UNITED STATES
DEPARTMENT OF THE INTERIOR
BUREAU OF LAND MANAGEMENT

8. Well Name and No. RATTLESNAKE 28 FED COM/403H

EOG respectfully requests an amendment to our approved APD for this well to reflect the following changes:

Rattlesnake 28 Fed Com 213H (FKA 403H) API #: 30-025-52619

Revised Wellbore

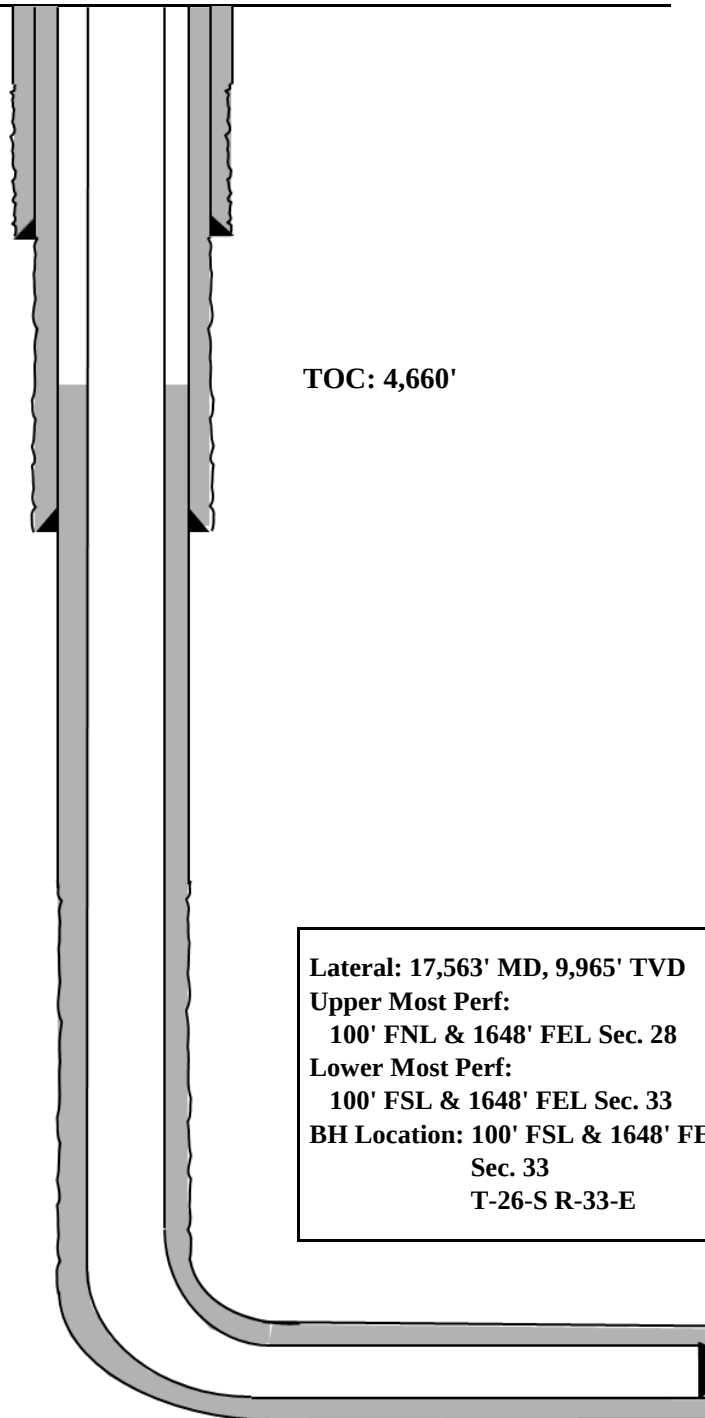
Change name from Rattlesnake 28 Fed Com 403H to Rattlesnake 28 Fed Com 213H.

Change BHL from T-26-S, R-33-E, Sec 33, 2438' FNL, 2587' FWL, Lea Co., NM, to T-26-S, R-33-E, Sec 33, 100' FSL, 1648' FEL, Lea Co., N.M.

Change target formation to Leonard B.

Bit Size: 13-1/2"
 10-3/4", 40.5#, J-55, STC
 @ 0' - 1,230'

Bit Size: 9-7/8"
 8-5/8", 32.#, J-55, BTC-SC
 @ 0' - 5,160'

TOC: 4,660'

Bit Size: 6-3/4"
 5-1/2", 20.#, P110-EC, DWC/C IS MS
 @ 0' - 17,563'

Lateral: 17,563' MD, 9,965' TVD
 Upper Most Perf:
 100' FNL & 1648' FEL Sec. 28
 Lower Most Perf:
 100' FSL & 1648' FEL Sec. 33
 BH Location: 100' FSL & 1648' FEL
 Sec. 33
 T-26-S R-33-E

KOP: 9,629' MD, 9,338' TVD
 EOC: 10,379' MD, 9,911' TVD

Salt Section Annular Clearance Variance Request

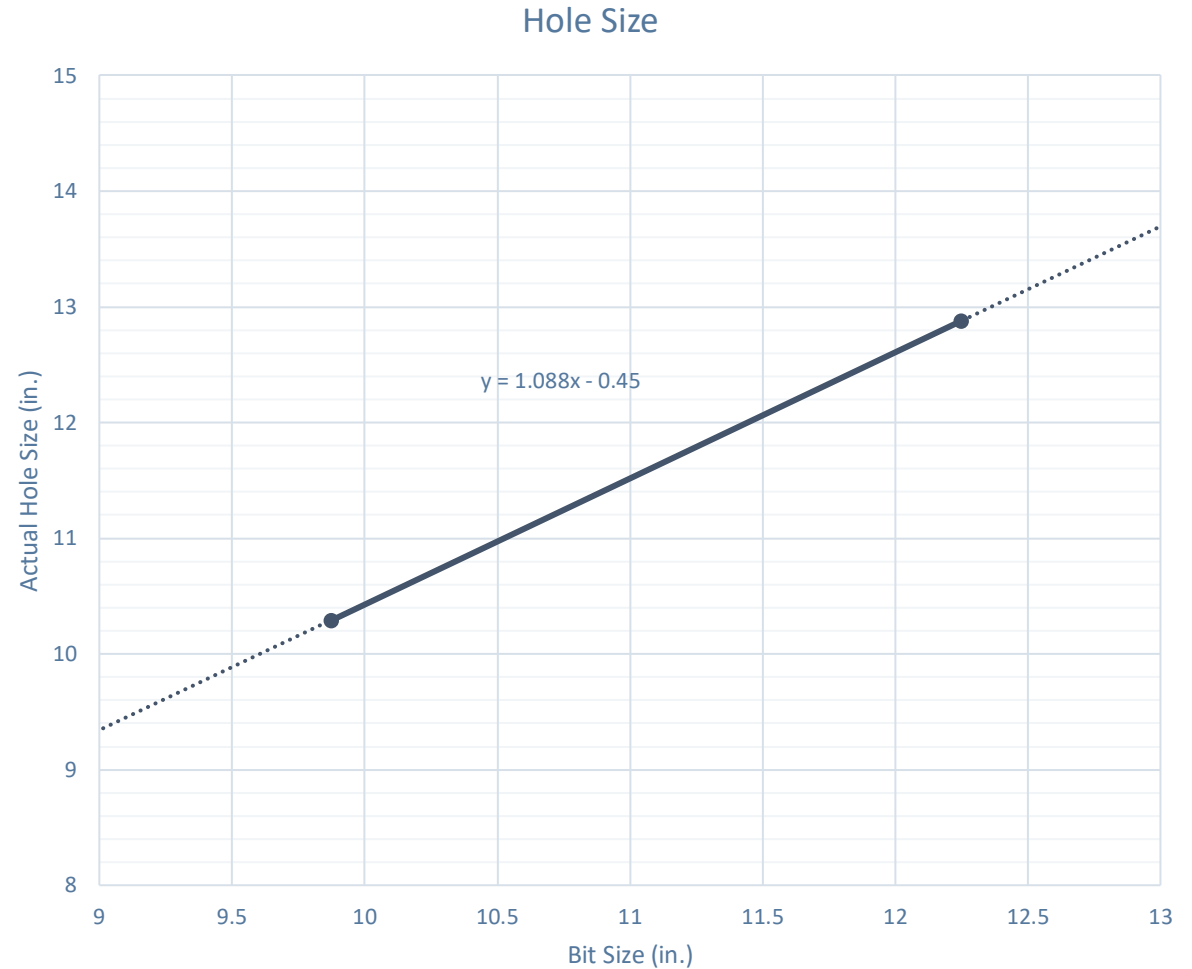
EOG request permission to allow deviation from the 0.422" annulus clearance requirement for the intermediate (salt) section from Onshore Order #2 under the following conditions:

- The variance is not applicable within the Potash Boundaries or Capitan Reef areas.
- Operator takes responsibility to get casing to set point in the event that the clearance causes stuck pipe issues
